Service Bulletin No: 34-038

Modification No: EC-13-0125

**NAVIGATION - ATTITUDE AND DIRECTION
MODIFICATION TO THE ELECTRONIC STANDBY INSTRUMENT-SYSTEM (ESIS) POWER RETURN
WIRES****1. Planning Information****A. Effectivity**

Installation of the Ground Stud GS125
Figure 1

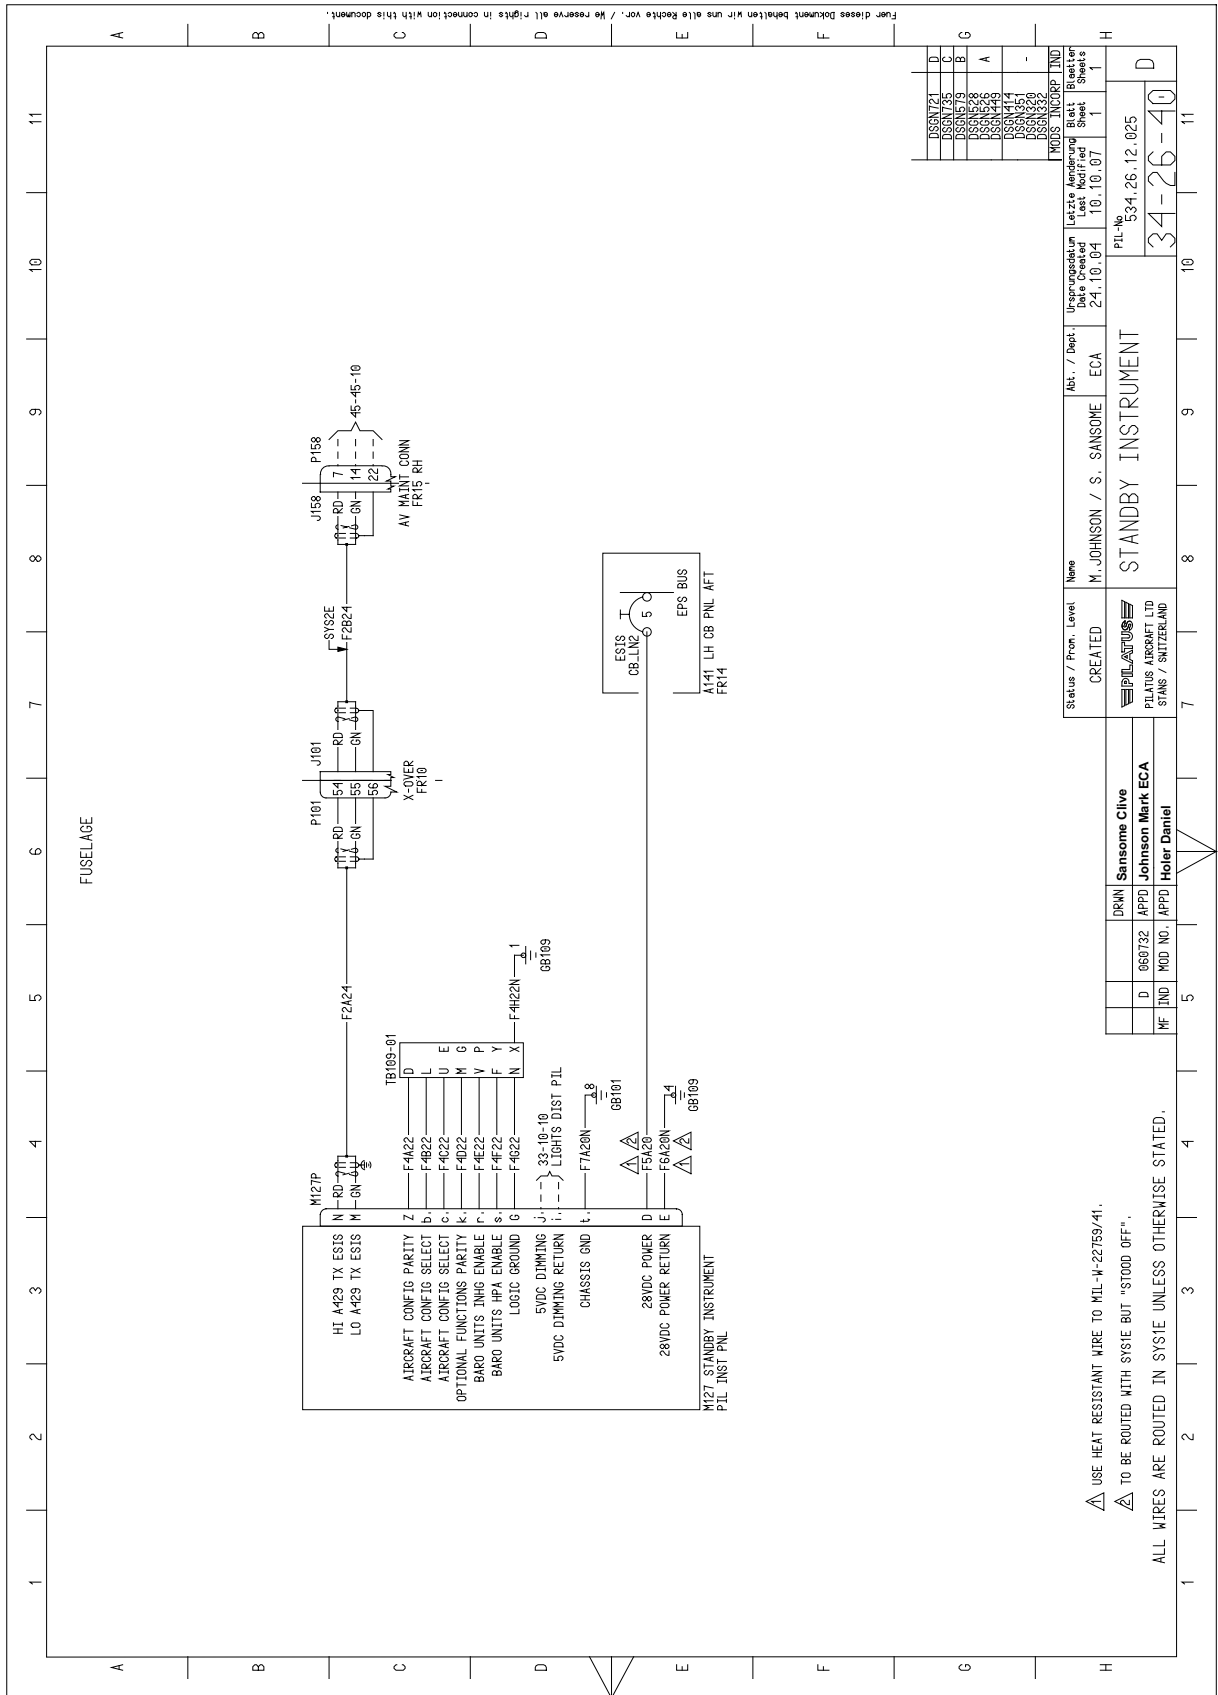
- 3 Remove the terminal pin from the wire.
- (2) Install the ground stud GS125 (Ref. Fig. 1):
 - (a) Find the hole for the ground stud GS125 (1) (P/N 591.30.12.031) in FR12, LH.

- (o) Hold the ground stud GS125 (1) (P/N 591.30.12.031) and torque the nut (10) (P/N 938.07.68.304) to between 2,3 and 2,9 Nm (20 and 25 lb in.).

NOTE: Do not forget to add the run down torque to the value given above (Ref. AMM, 12-B-20-20-01-00A-040A-A).
 - (p) Do an electrical continuity test between the ground stud GS125 and the aircraft structure (pilots seat rail or similar). The resistance must be less than 5 mΩ.
- (3) Connect the wires to the ground stud GS125 (Ref. Fig. 6 - Hook-Up Chart):
- (a) For Config. 1 aircraft (Ref. Fig. 1 and 3):
 - 1 For the wire F6A20N.
 - a Make a note of the position of the cable ties that attach this wire to other wires in the aircraft.
 - b Cut the cable ties, if necessary, to remove this wire from the other wires in the aircraft.
 - c Route the wire to the ground stud GS125 (1, Fig. 1) (P/N 591.30.12.031) (Ref. Fig. 3).
 - d Cut the wire to length and install a terminal lug (2) (P/N 971.31.18.830) (Ref. Line 3 of the Hook-Up Chart, Fig. 6).

Wiring Diagram - Config 1 Aircraft - Pre Service Bulletin
Figure 2

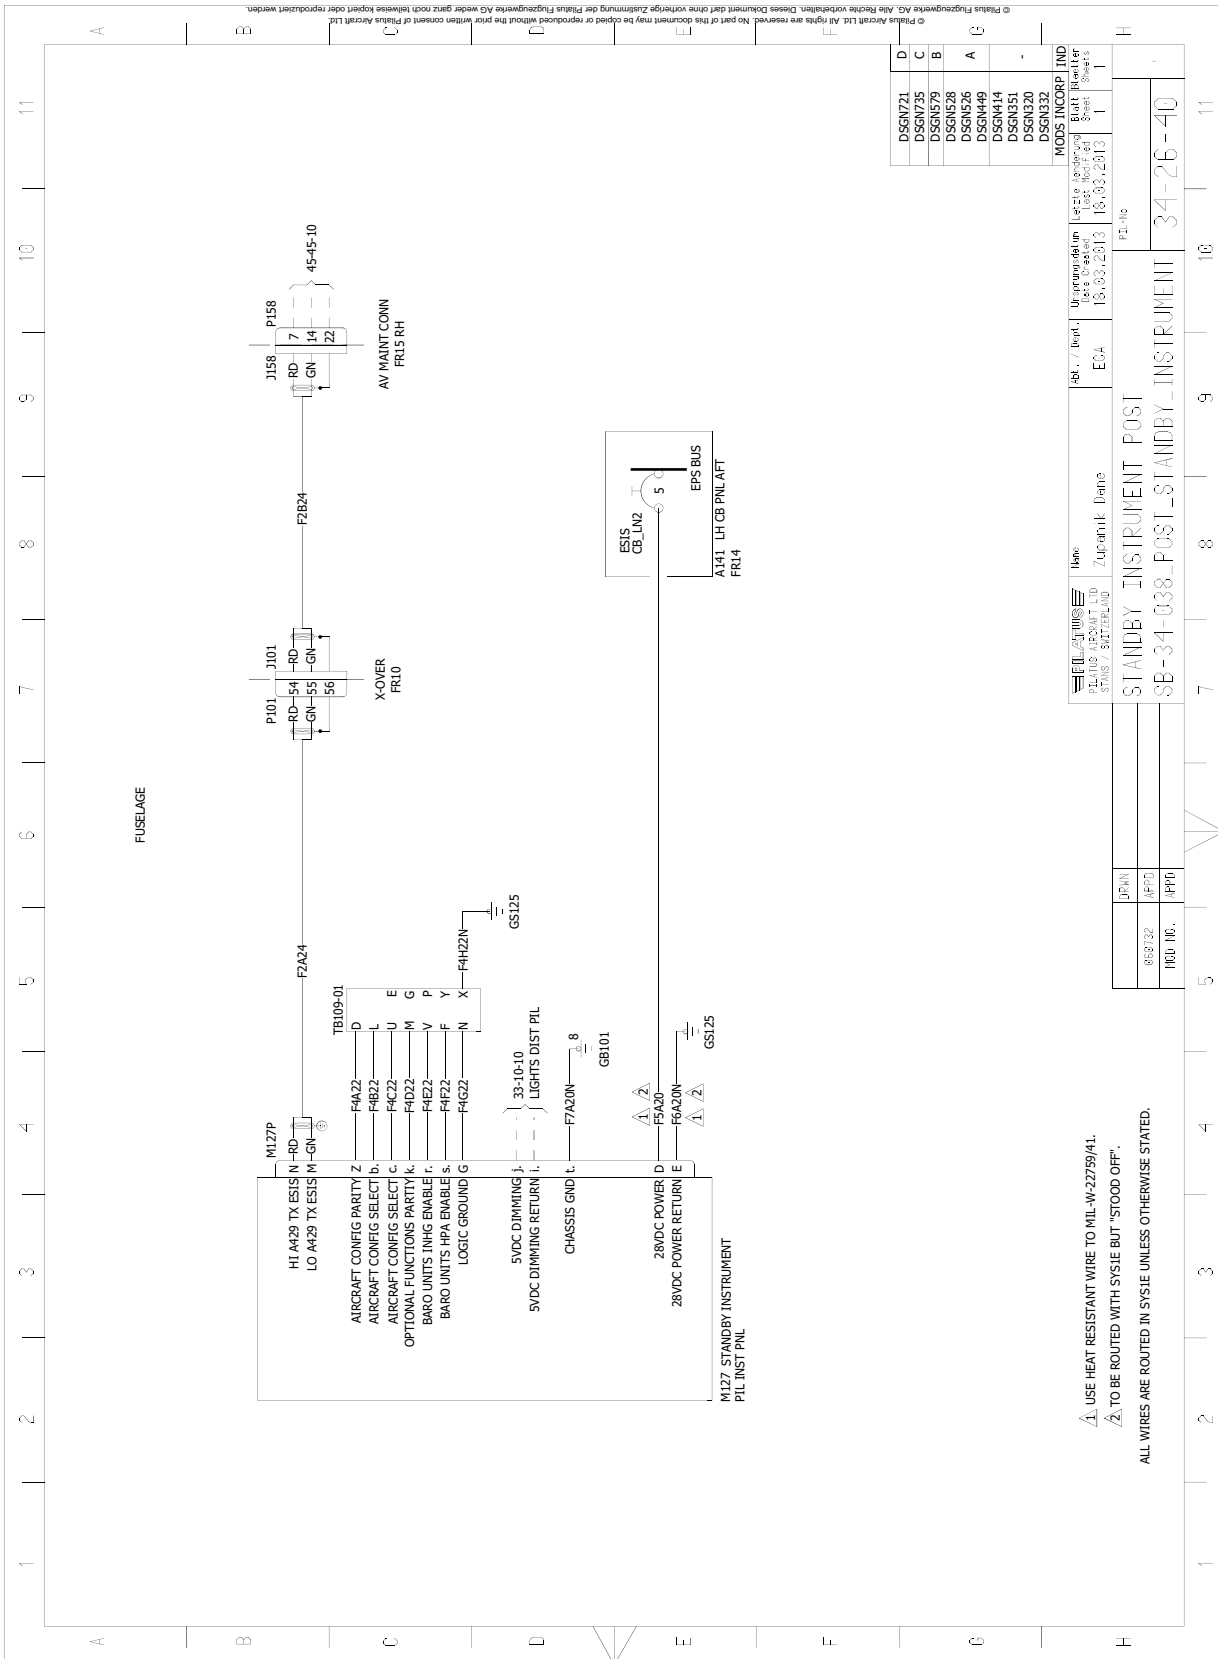
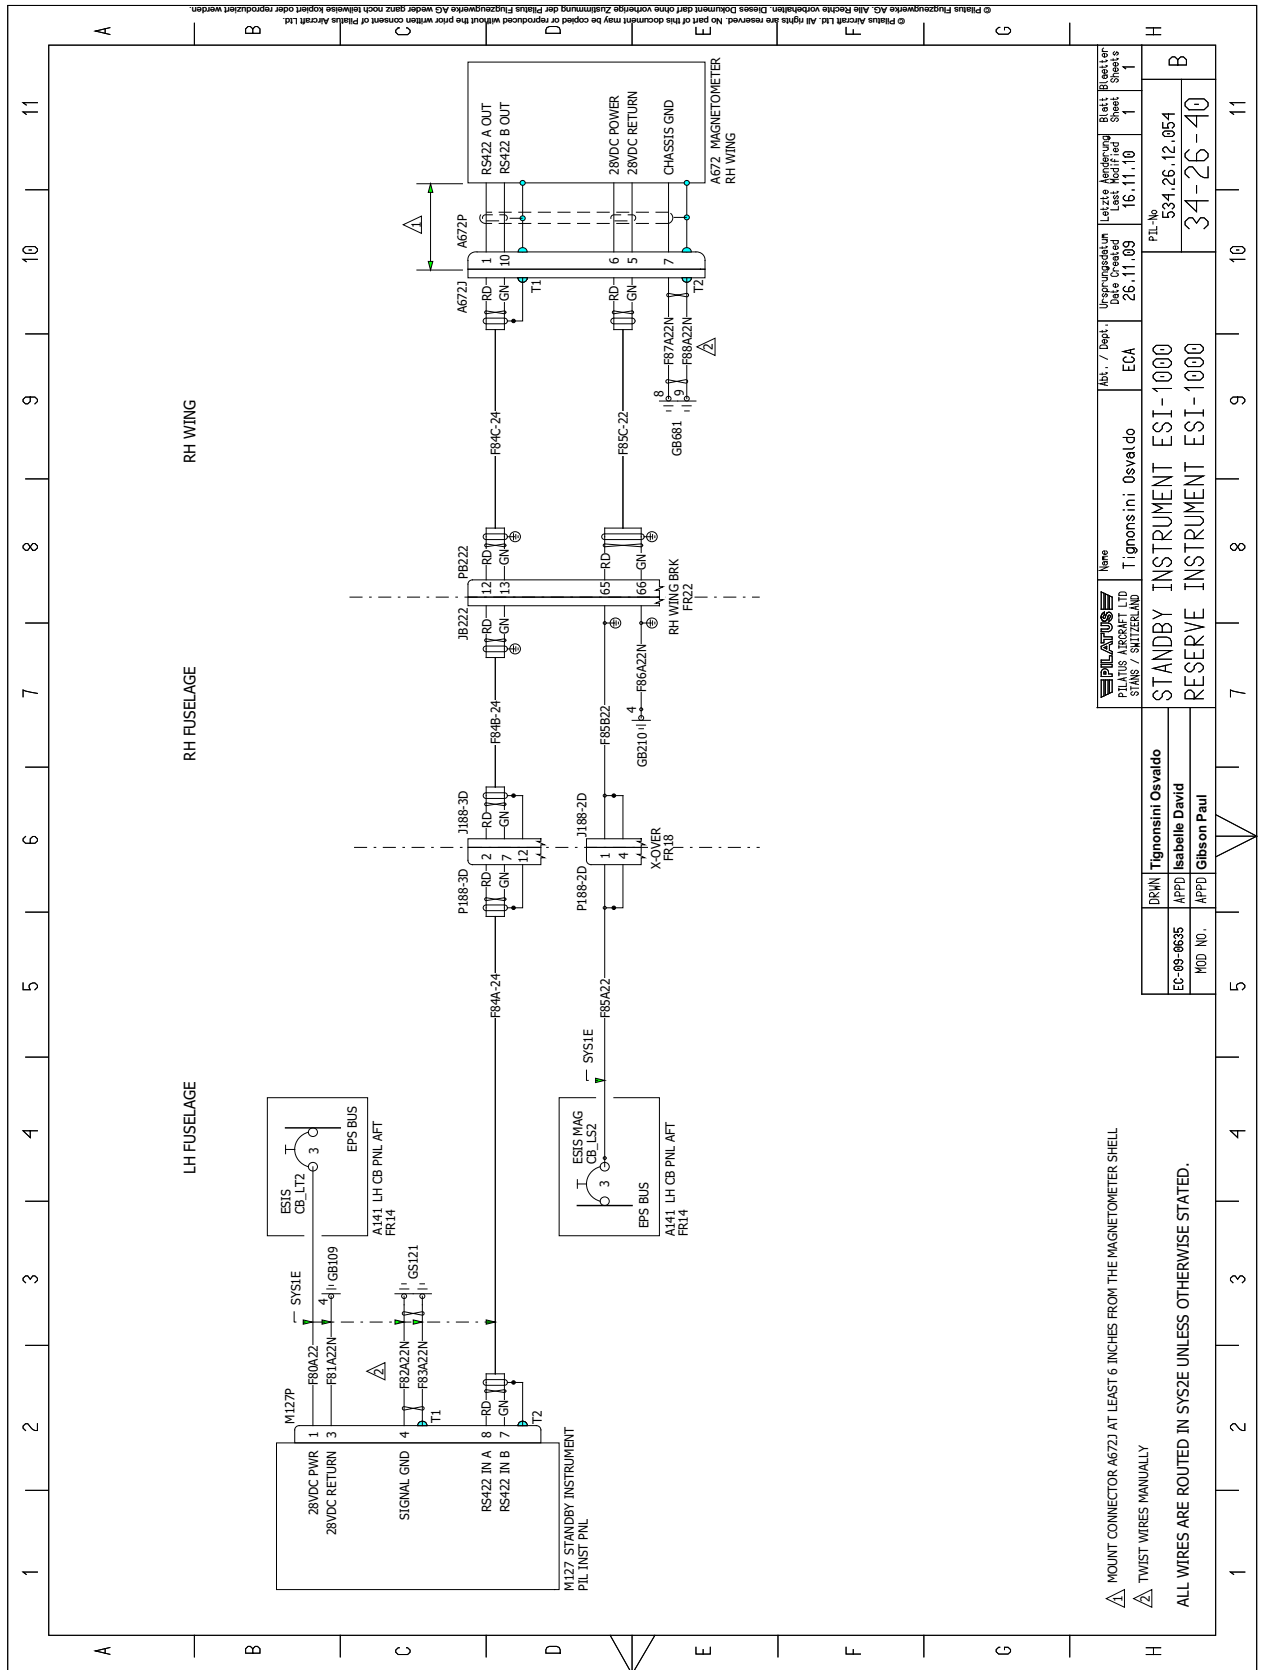
- (b) For Config. 1 aircraft (Ref. Fig. 2):
 - 1 Locate the wire F6A20N.
 - 2 Disconnect the wire from position 4 of the grounding block GB109 (Ref. Line 1 of the Hook-Up Chart).

- 3 Remove the terminal pin from the wire.
 - 4 Locate the wire F4H22N.
 - 5 Disconnect the wire from position 1 of the grounding block GB109 (Ref. Line 2 of the Hook-Up Chart).

- c Install pin module (P/N 971.42.31.535) to the wire (P/N 919.79.41.302) and connect to TB109-01 terminal X (Ref. Fig. 3).
 - d Route the wire from TB109-01 terminal X to the ground stud GS125 (1, Fig. 1) (P/N 591.30.12.031) (Ref. Fig. 3).

Wiring Diagram - Config 2 Aircraft - Pre Service Bulletin
Figure 4

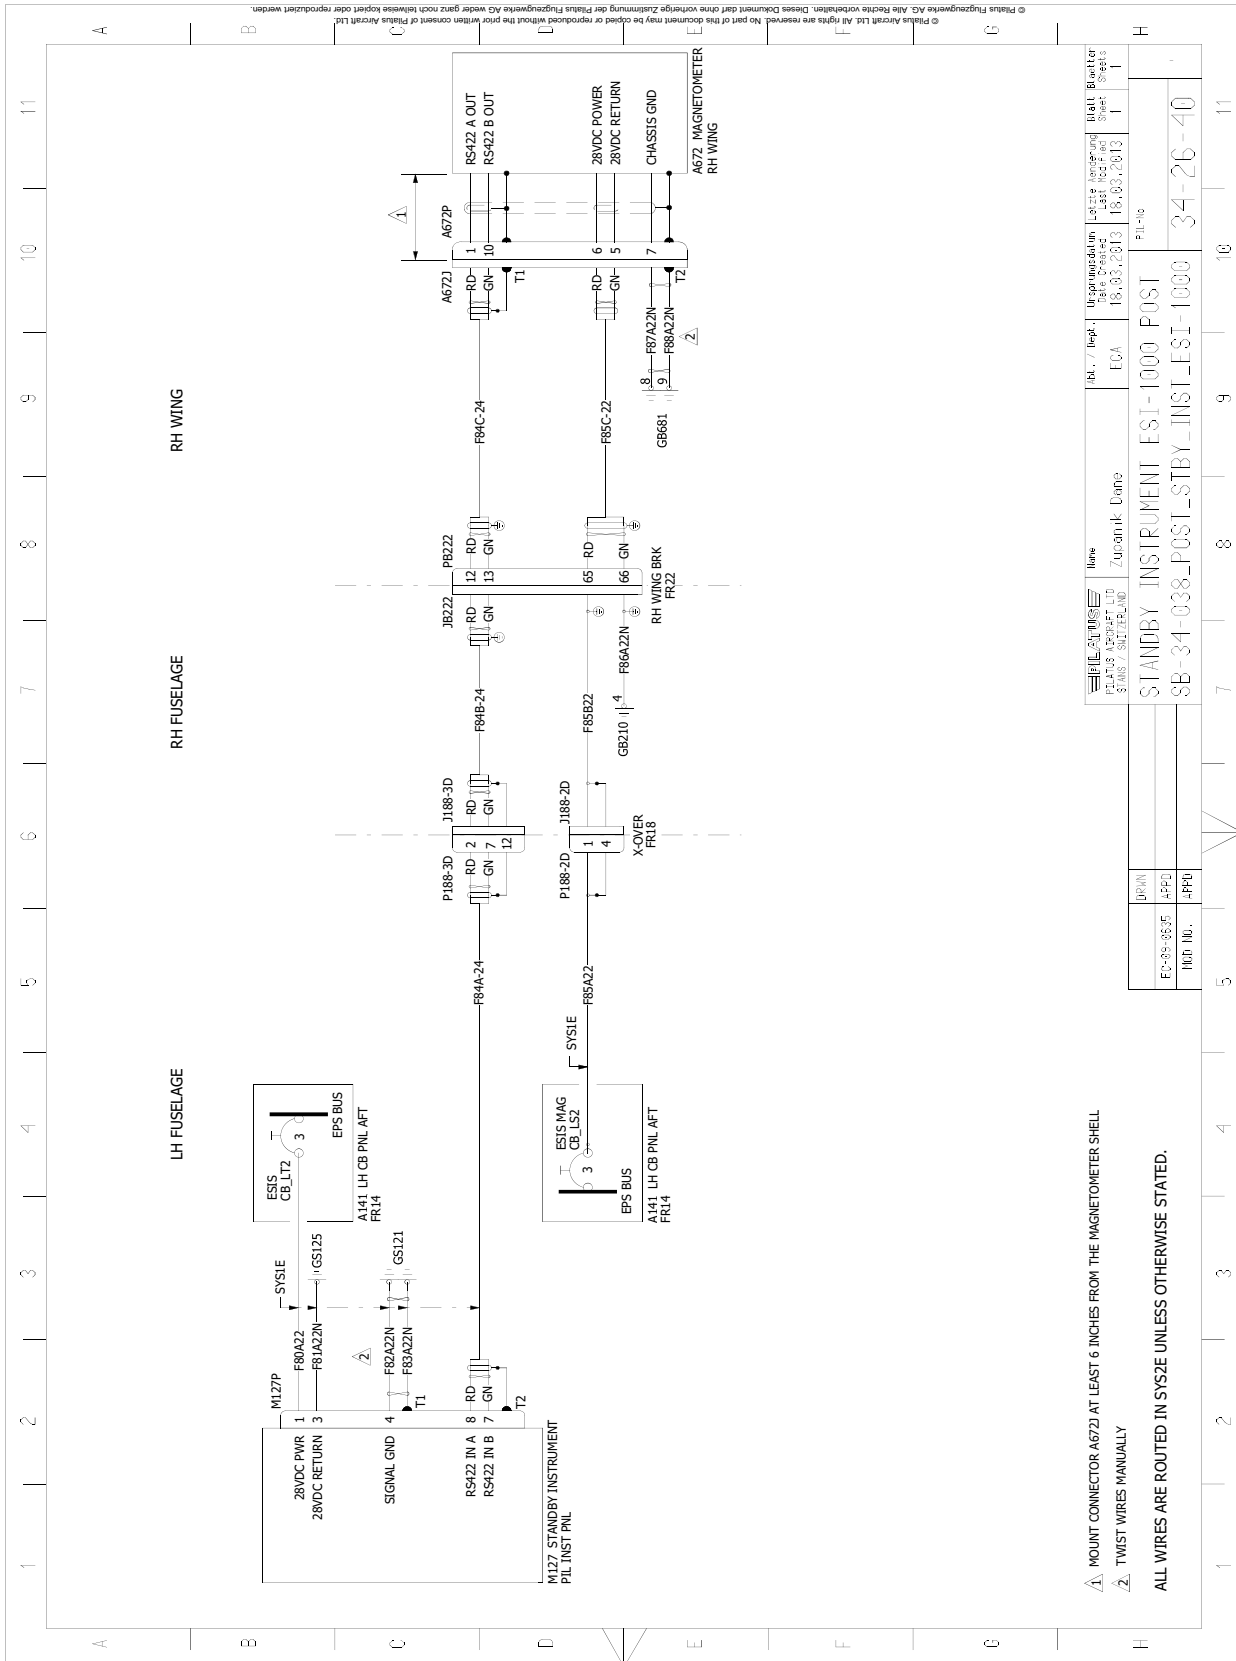
- 6 Remove the terminal pin from the wire.
 - (c) For Config. 2 aircraft (Ref. Fig. 4):
 - 1 Locate the wire F81A22N.
 - 2 Disconnect the wire from position 4 of the grounding block GB109 (Ref. Line 5 of the Hook-Up Chart).

- b Cut the cable ties, if necessary, to remove this wire from the other wires in the aircraft.
 - c Route the wire to the ground stud GS125 (1, Fig. 1) (P/N 591.30.12.031) (Ref. Fig. 5).
